Environmental Planning Commission

*Agenda Number: 02
Project Number: 1002132
Case #: 16EPC-40001, 40002, 40003
March 10, 2016*

Staff Report

Agent	Consensus Planning Inc.
Applicant	Paul Hedges / Guardian Storage
Request	Zone Map Amendment (Zone Change), Site Development Plan for Subdivision Amendment, Site Development for Building Permit
Legal Description	Tract A-1, plat of tracts A-1 and B-1 Village Center North Subdivision & Tract C, bulk land plat of Village Center North Subdivision
Location	On Unser Boulevard, between Summer Ridge Dr. and McMahon Blvd.
Size	Approximately 2.61 Acres
Existing Zoning	SU-1 for Mixed Use, C-1 & SU-1 for Mixed Use, O-1
Proposed Zoning	SU-1 for Mixed Uses for C-1, O-1 and Indoor Storage Uses

Sheet 3 of 6

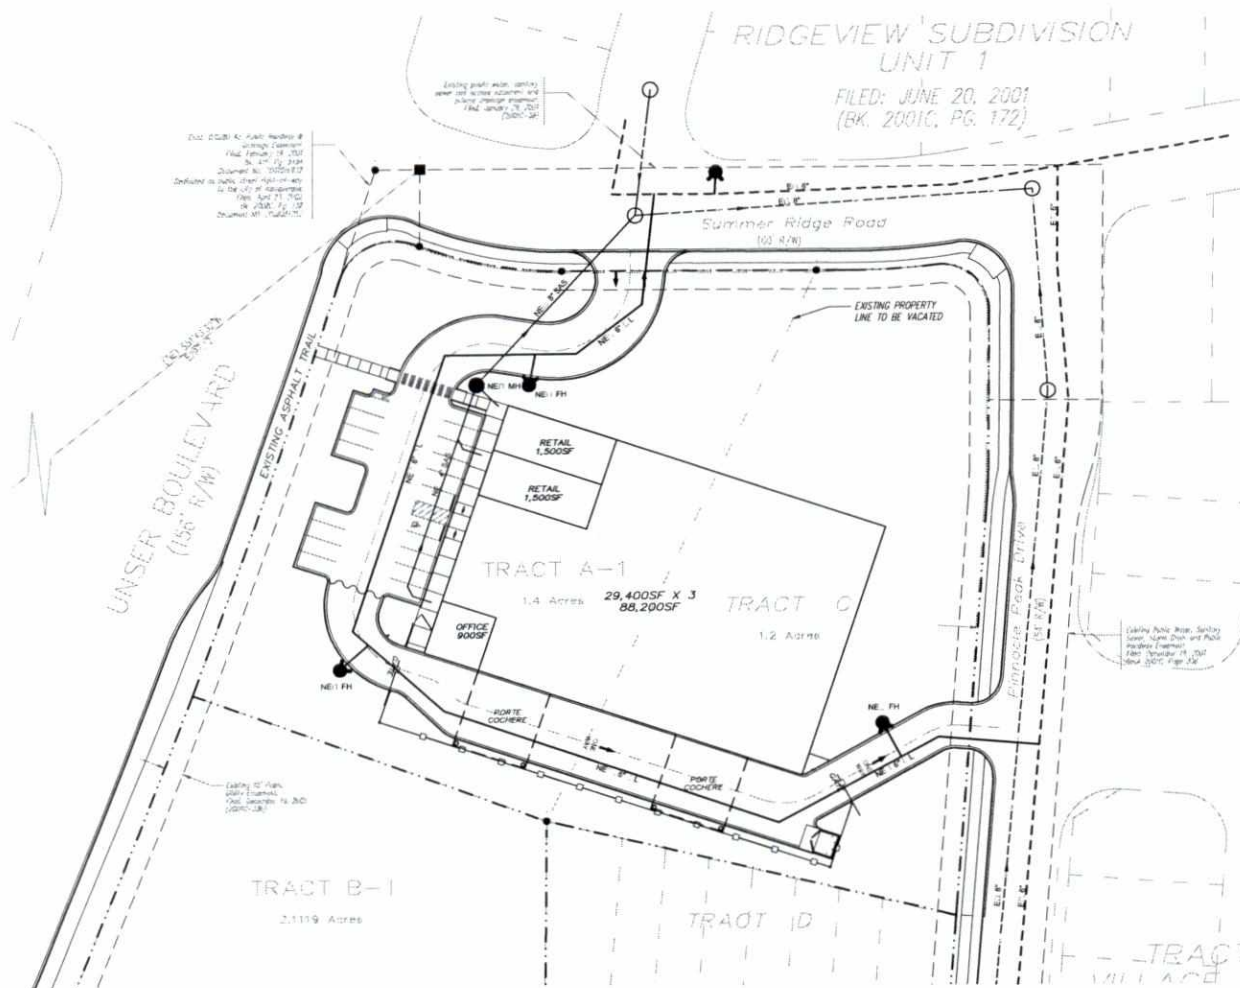
The applicant did not submit a formal grading and drainage narrative with the conceptual Grading and Drainage Plan on Sheet 3 of 6. Drainage flows for the subject site appear to flow south to north toward a proposed temporary retention pond for landscape and roof water is proposed at the northeastern portion of the subject site as well as into an existing drainage easement and outlet along Summer Ridge Rd. When future expansion is considered the depression will be removed and storm water is proposed to discharge onto adjacent streets. The Grading and Drainage Plan on Sheet 3 of 6 will need to be revised to include a formal narrative outlining required grading and drainage details.

7. The Grading and Drainage Plan on Sheet 3 of 6 shall be revised to include a grading and drainage narrative that includes: site data (legal description and location), existing conditions, proposed improvements, first flush requirements calculations, and drainage approach.

SHEET 6 OF 6

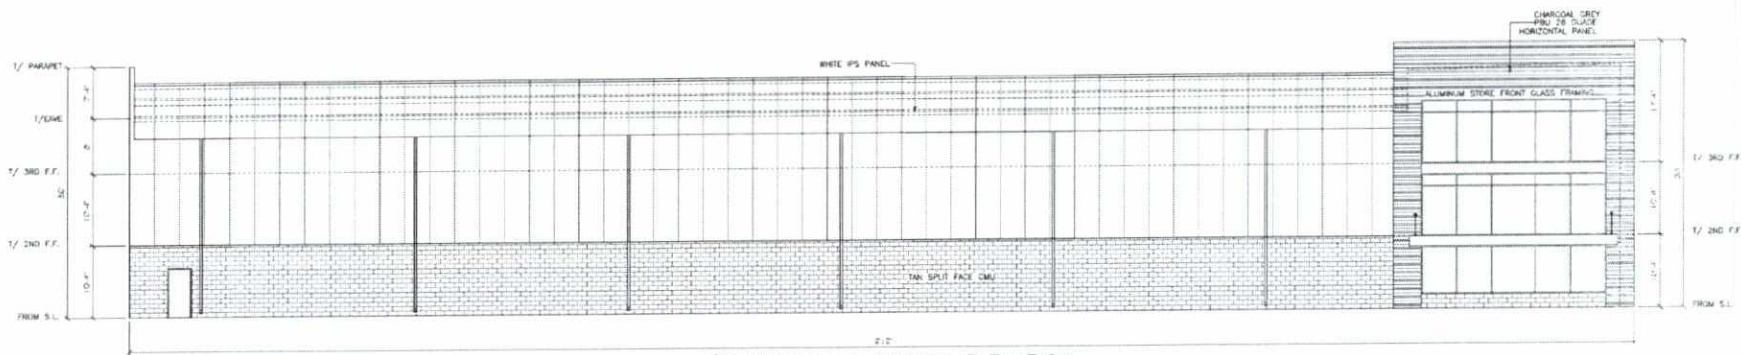
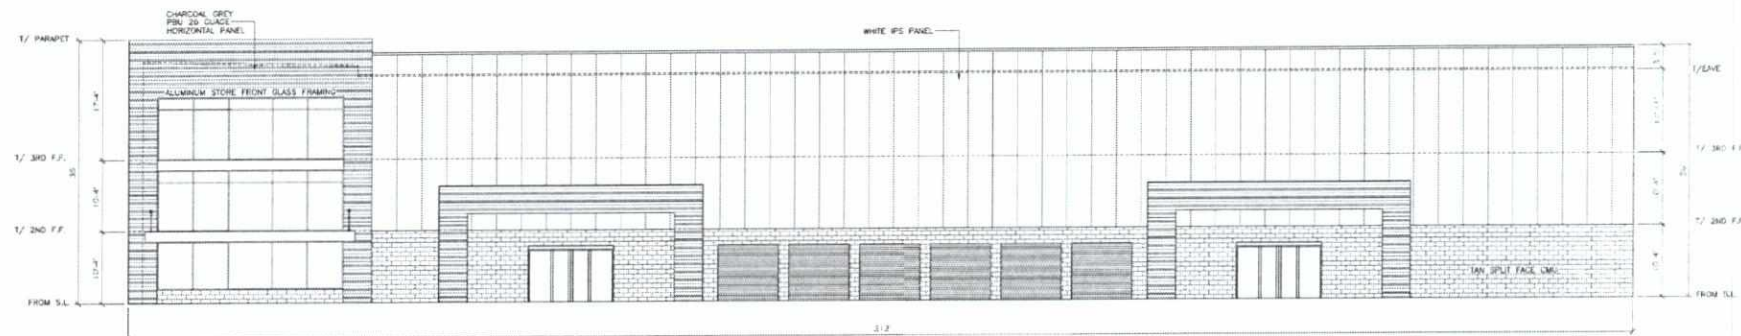
Due to the fact that the storage facility is proposed to be 38' in height, the design parameters of the Unser / McMahon Village Center North Site Development Plan for Subdivision require that the applicant include a 45 degree angle plane diagram. Sheet 5 of 6 or Sheet 6 of 6 will need to be revised to include the angle plane detail and demonstrate compliance with the stated design parameters.

4. The Elevations on Sheet 6 of 6 shall be revised to include notations stating that the lighting plan for the subject site will conform to the Area Lighting Regulations of the Zoning Code (§ 14-16-3-9, and that lighting fixtures must include a cut-off angle, not directly shine on any public right-of-way or any other residential premises and shall not have an off-site luminance greater than 200 foot-lamberts measured from any private property in a residential zone.

5. The Elevations on Sheet 6 of 6 shall be revised to include detailed light pole and fixture dimensioned drawings demonstrating compliance with Area Lighting Regulations of the Zoning Code (§ 14-16-3-9).

-
6. The Elevations on Sheet 6 of 6 shall be revised to include notations stating that the lighting plan for the subject site will conform to the State of New Mexico Night Sky Protection Act (74-12-1 to 74-12-10 NMSA 1978).

8. The Elevation Sheet 6 of 6 shall be revised to include a 45 degree angle plane diagram to fulfill the design parameter requirements of the Unser / McMahon Village Center North Site Development Plan for Subdivision because the building is proposed to be taller than 26'.
